PLAN CHANGE 92 – SUMMARY OF CHANGES TO RECOMMENDATIONS BASED ON COUNCIL EVIDENCE – 6 SEPTEMBER 2023

The purpose of this document is to update the recommended changes which were published in the following documents at the time of releasing the Section 42A report:

Attachment A – Recommended Changes to District Plan Maps

Attachment B – Recommended Changes to District Plan Text

**Omokoroa Structure Plan - Stage 3 - Plan Change 92
Infrastructure - Roading and Walkway/Cycleway**

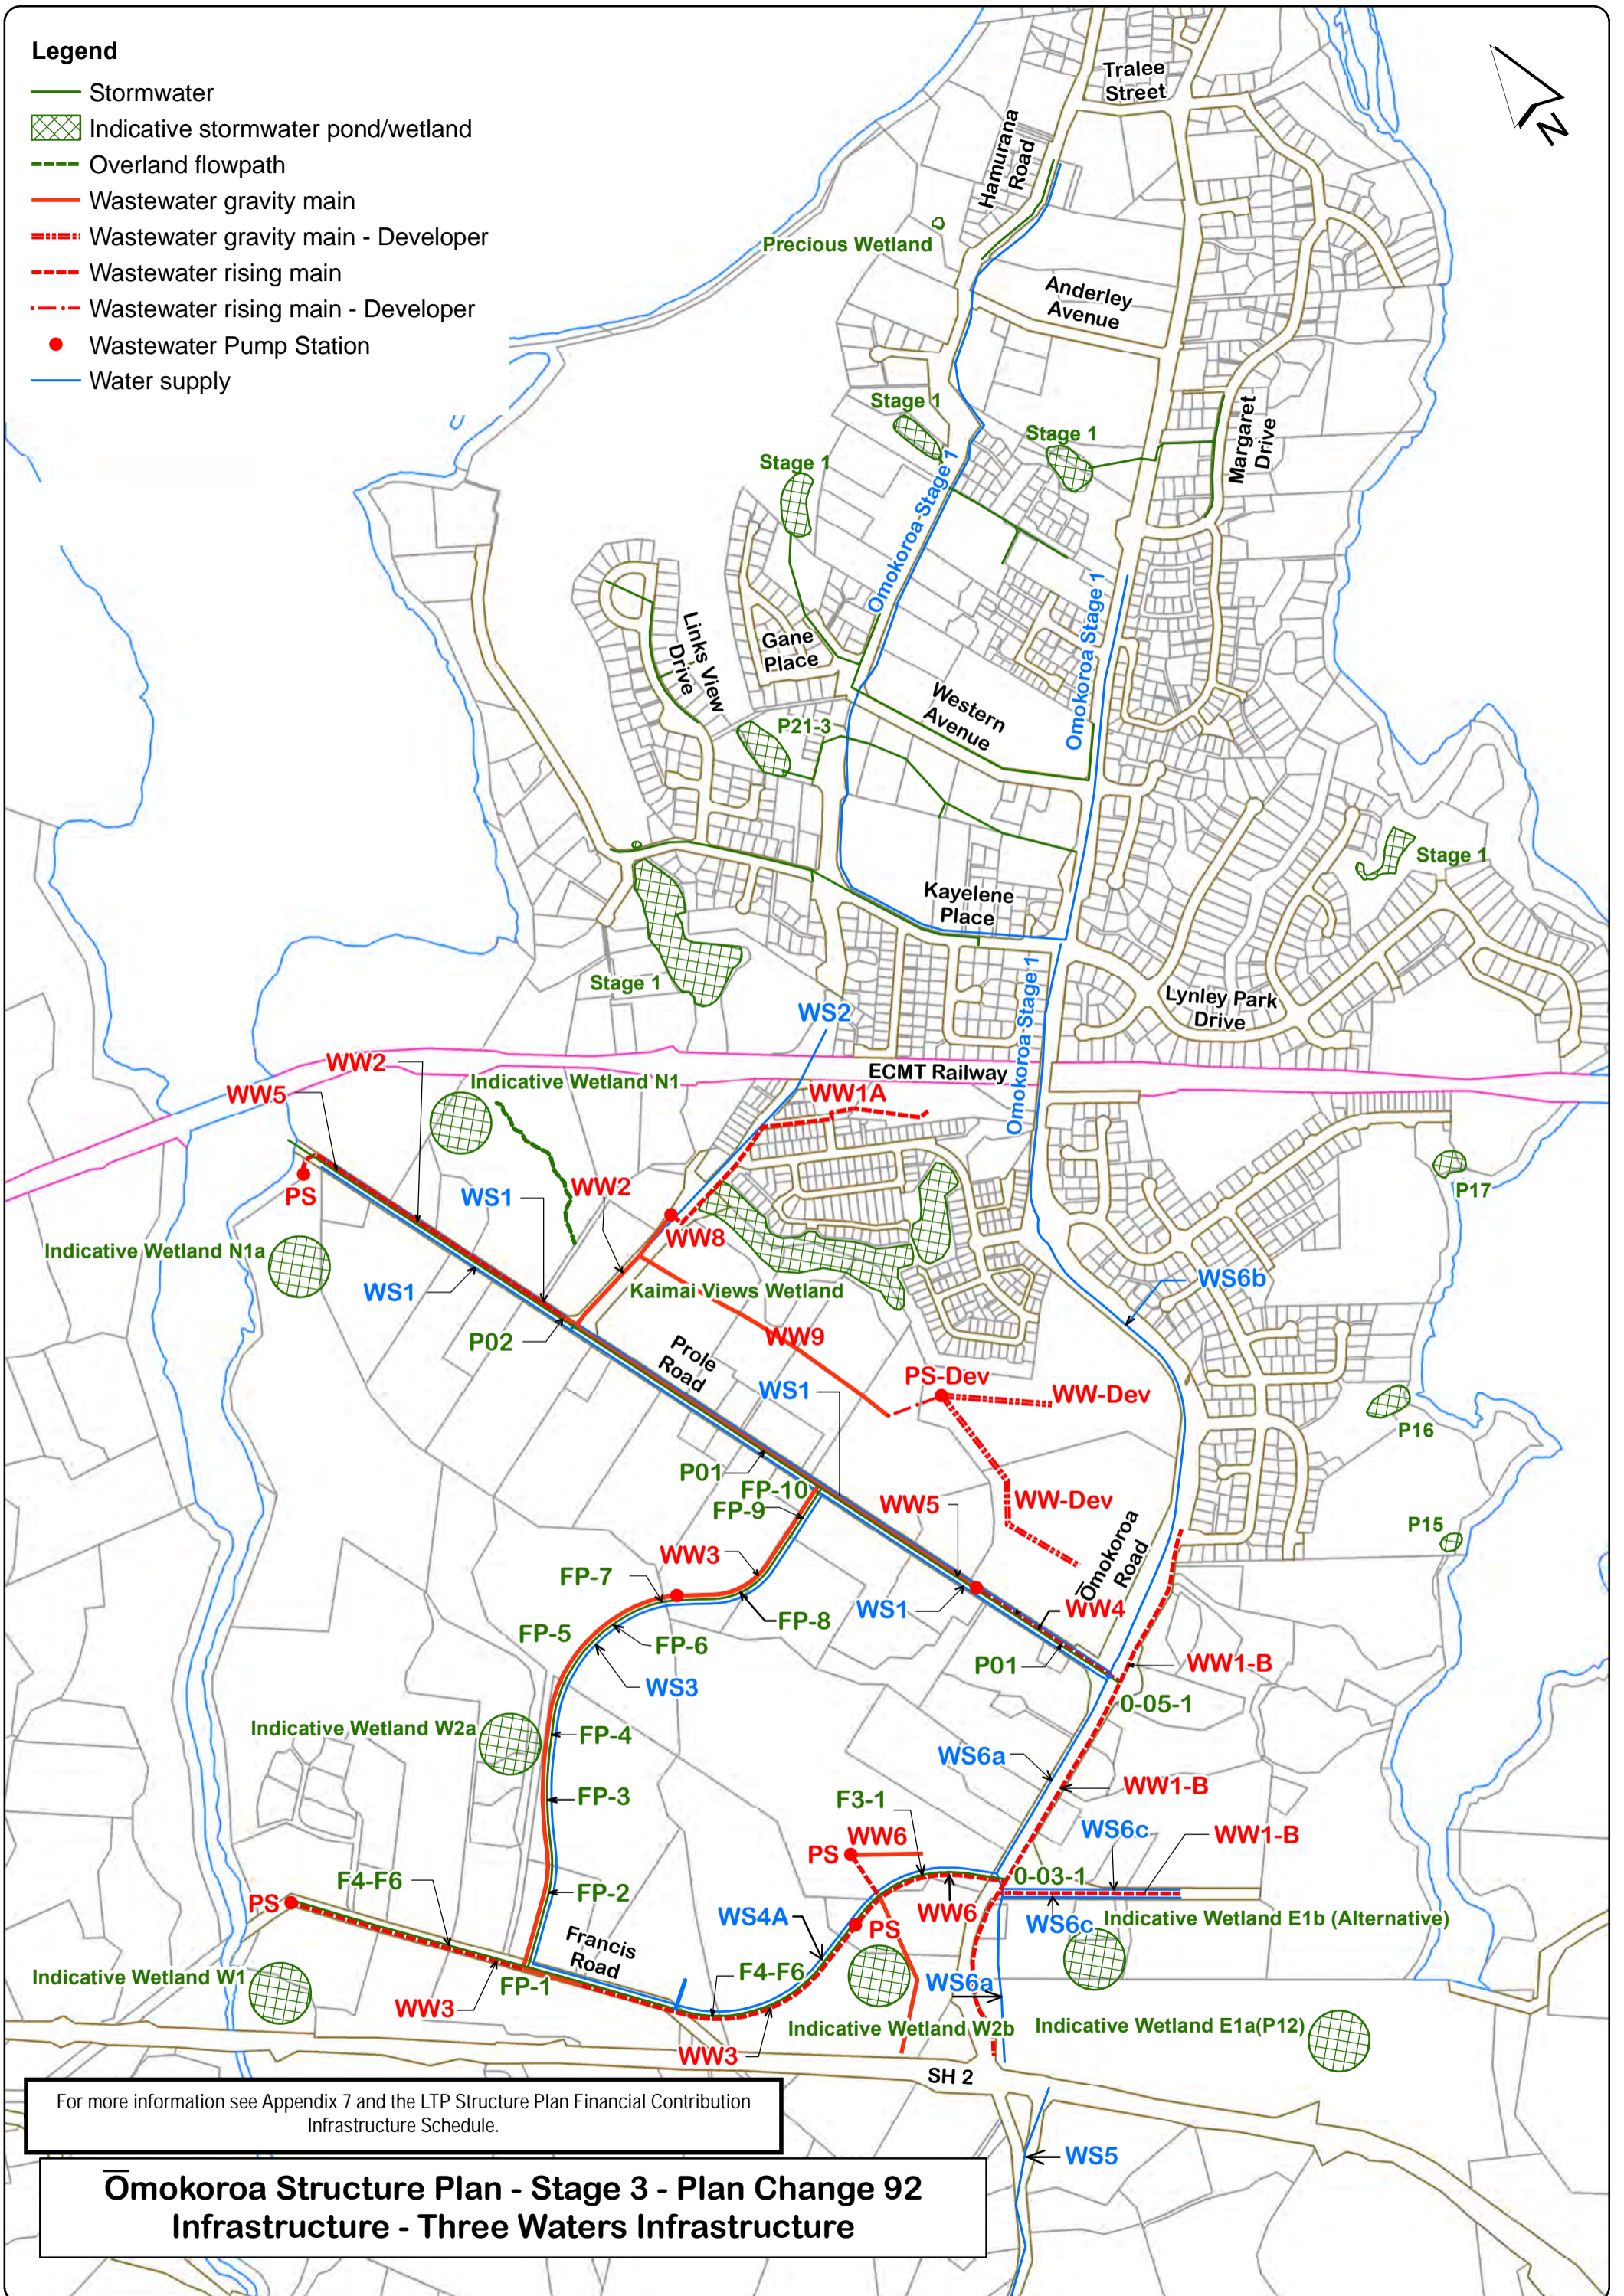
- **Ōmokoroa Structure Plan – Stage 3 – Plan Change 92 Infrastructure – Roading and Walkway/Cycleway Map:** Further amend the structure plan map so that the location of the roundabout serving 60 Prole Road, matches the current detailed engineering design, and make consequential changes to roading alignment.

**Omokoroa Structure Plan - Stage 3 - Plan Change 92
Infrastructure - Three Waters Infrastructure**

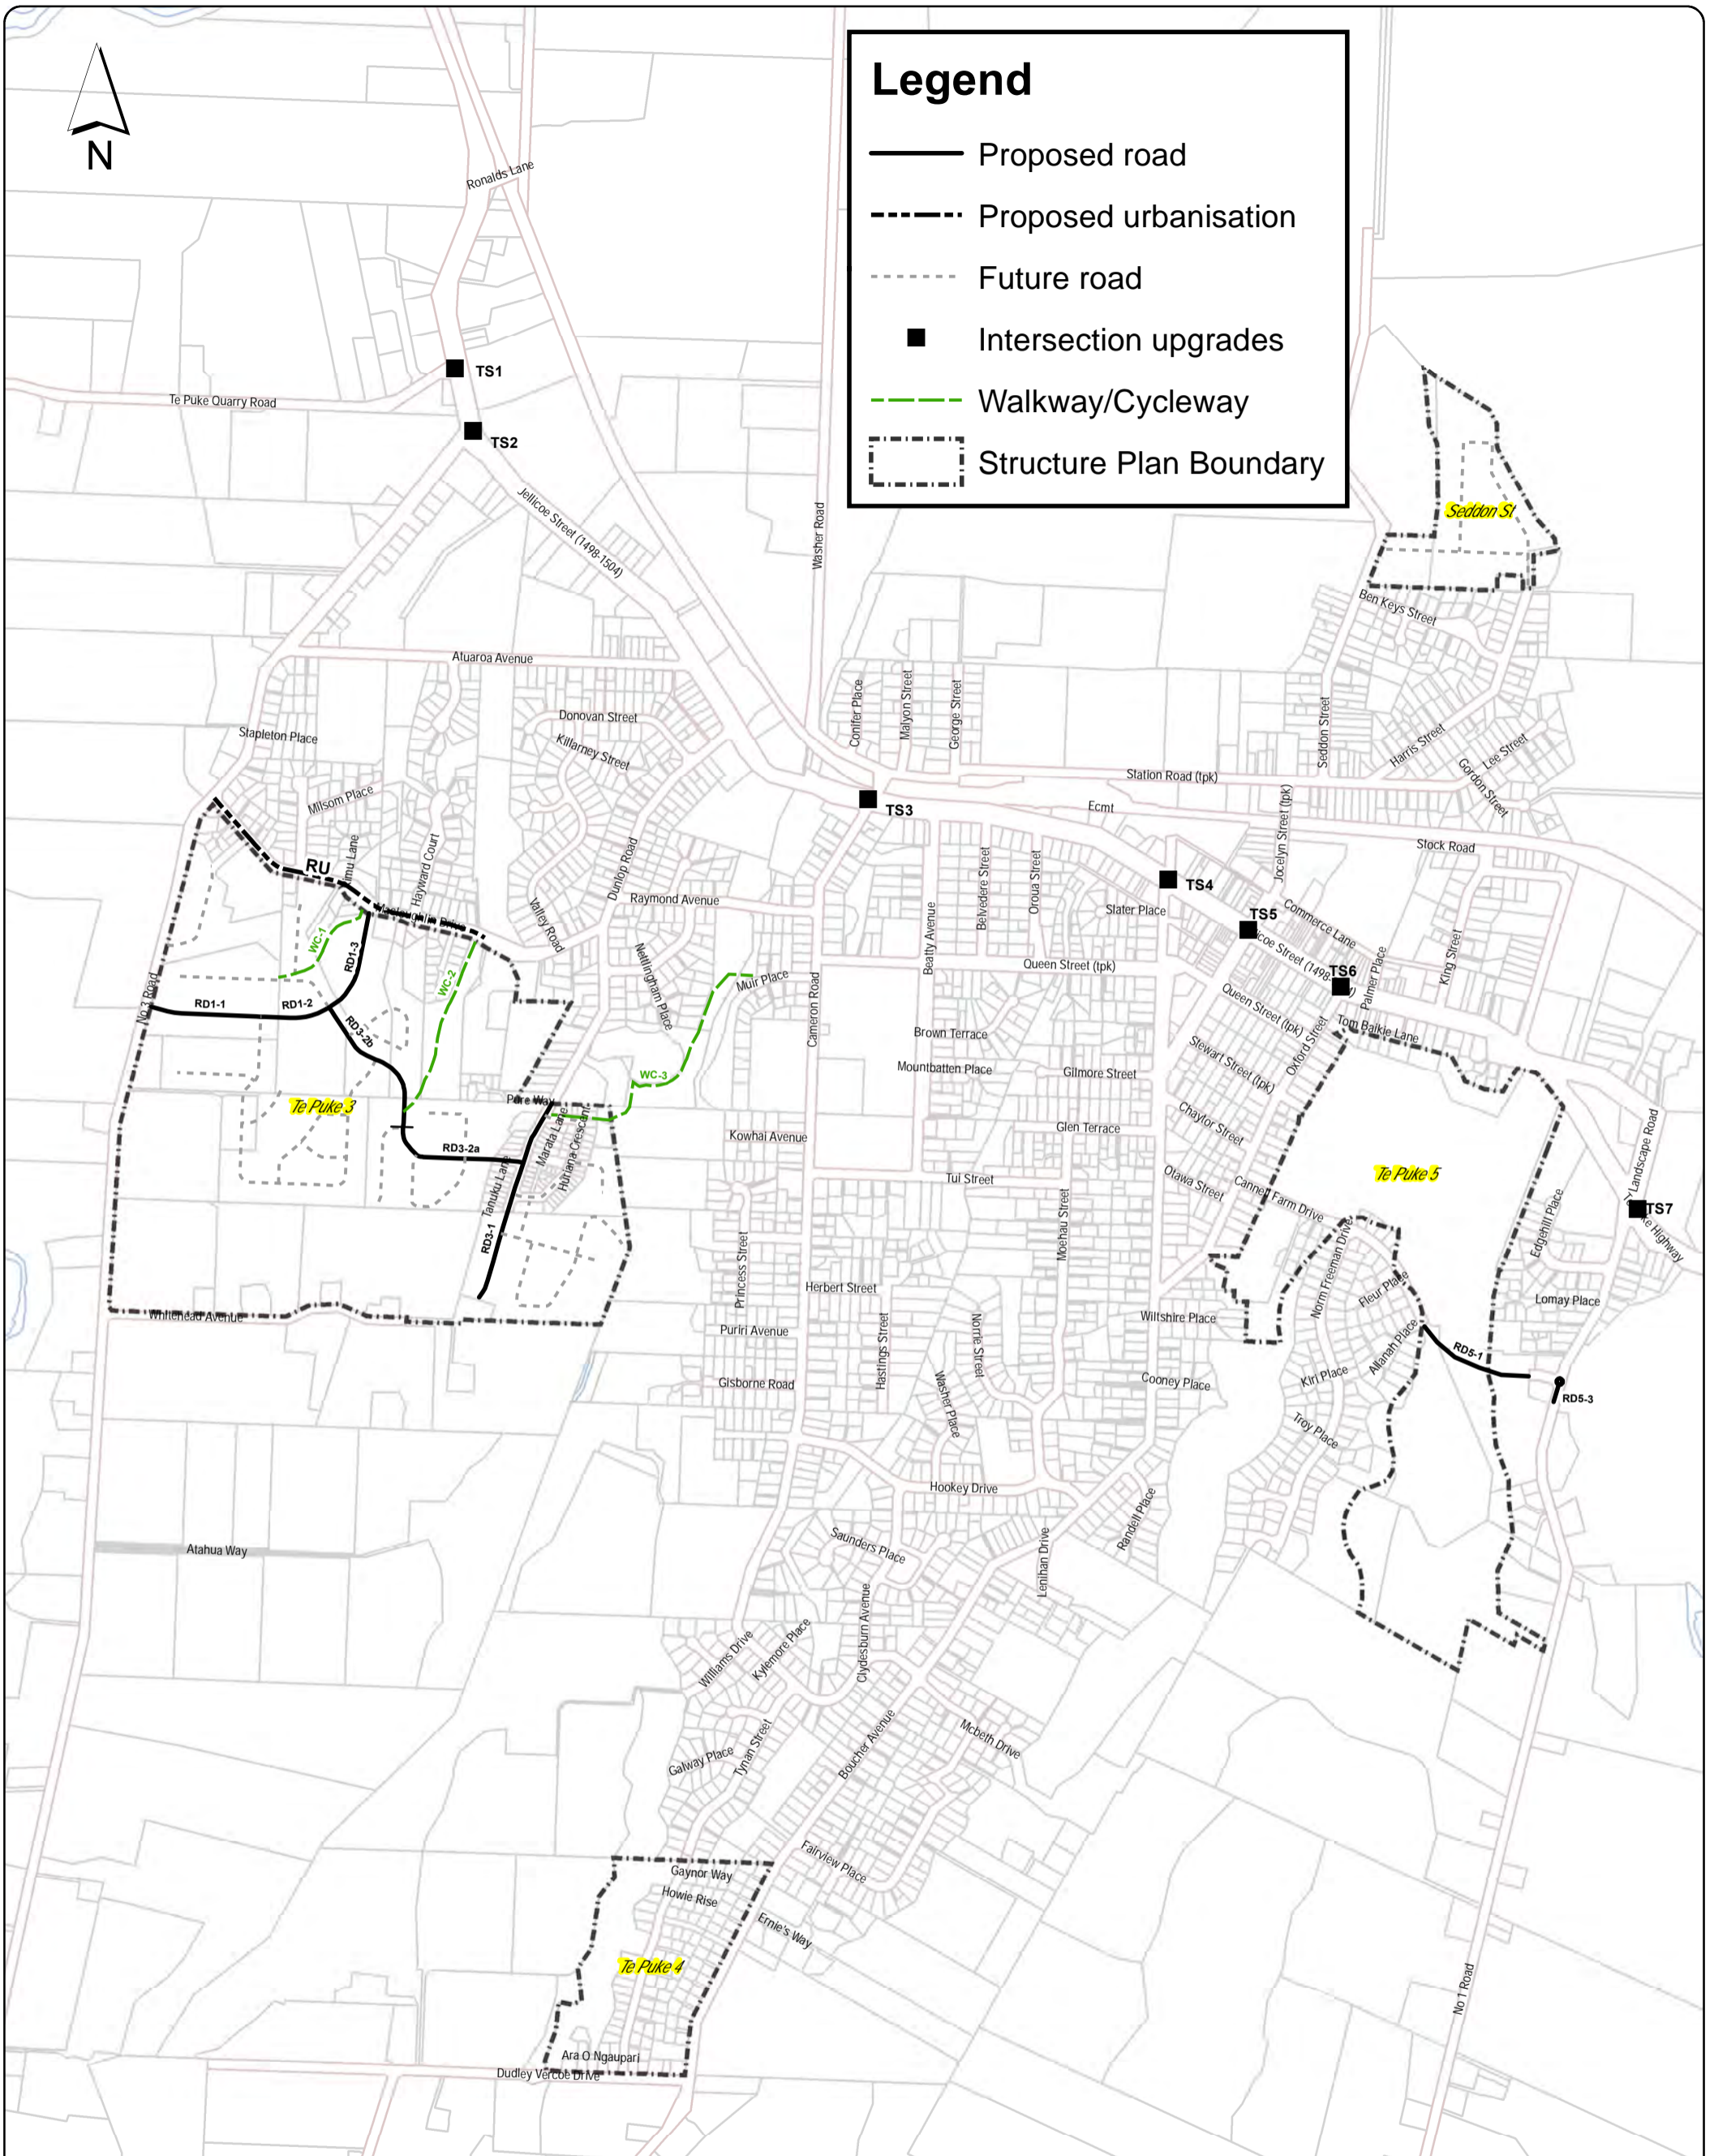
- **Ōmokoroa Structure Plan – Stage 3 – Plan Change 92 Infrastructure – Three Waters Infrastructure:** Further amend the structure plan map to make consequential changes as a result of relocating the roundabout serving 60 Prole Road.

Te Puke Structure Plan- Plan Change 92
Infrastructure - Three Waters Infrastructure

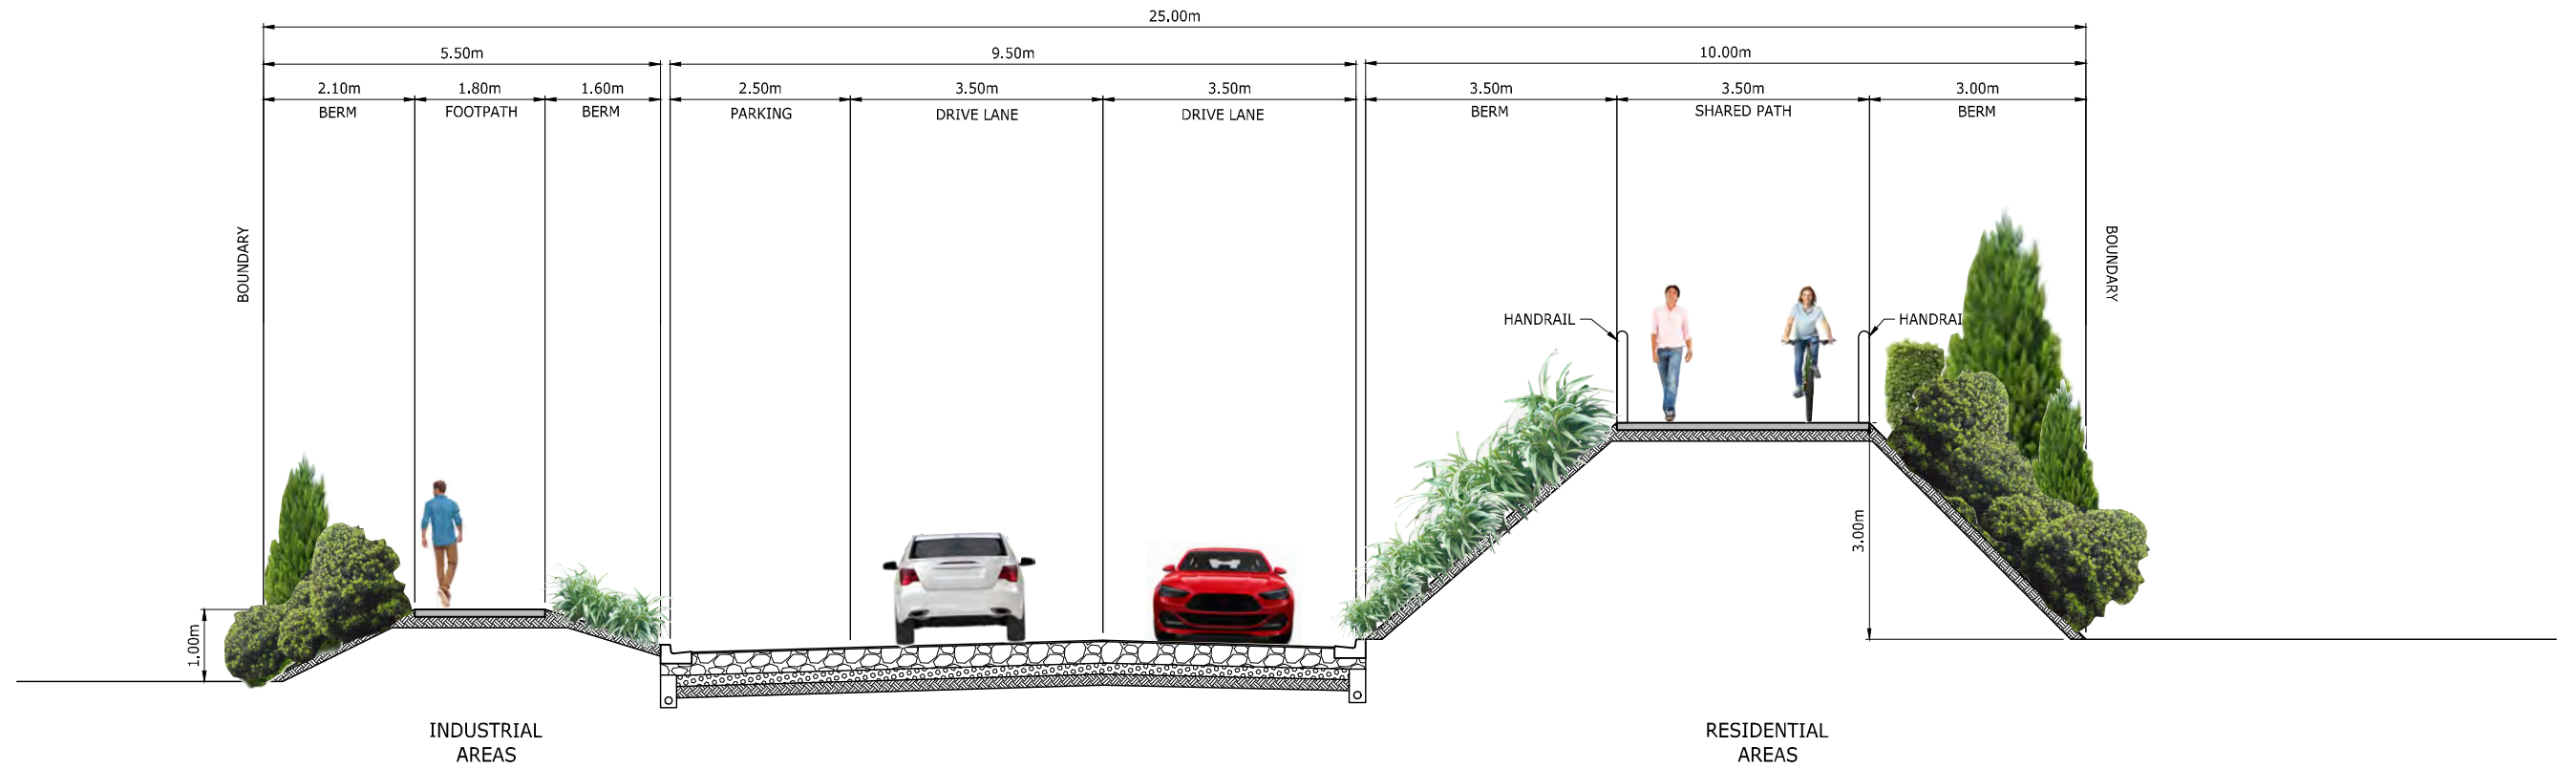
- **Ōmokoroa Structure Plan – Stage 3 – Concept Plan:** Further amend the concept plan to match changes to the zoning map and structure plans.
- **Te Puke Structure Plan – Plan Change 92 Infrastructure – Three Waters Infrastructure:** Delete projects WWINT-1 and WWINT-2 from the structure plan.
